UNITED STATES PATENT AND TRADEMARK OFFICE

APPLICATION NO.	FILING DATE	FIRST NAMED INVENTOR	ATTORNEY DOCKET NO.	CONFIRMATION NO.
10/532,518	04/25/2005	Thomas Dunker	Dunker, T. ET AL - 1 PCT	6031
25889	7590	03/17/2009		
COLLARD & ROE, P.C. 1077 NORTHERN BOULEVARD ROSLYN, NY 11576			EXAMINER STOUT, MICHAEL C	
			ART UNIT	PAPER NUMBER
			3736	
			MAIL DATE	DELIVERY MODE
			03/17/2009	PAPER

Office Action Summary

DETAILED ACTION

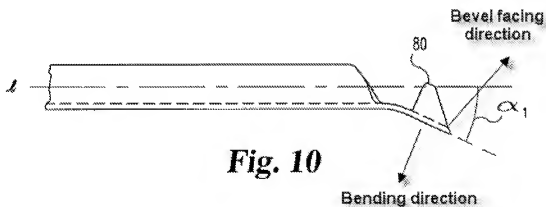
Miller teaches a biopsy holding device comprising a flexible distal section having a proximal and distal and a tip at said distal end with beveling arranged at the tip (cutting edge 81, see Figures 10 and 11 and Column 5, Lines 9-32), said distal section being bent in a bending direction at a pre-stress angle arranged at the proximate end of the distal section (Figure 10 shows the distal section being bent at an angle α_1 in a bending direction),

said beveling facing away from the bending direction (see Figure 10 above), so that the wire including the wire tip glides along the inner wall of the biopsy cannula when
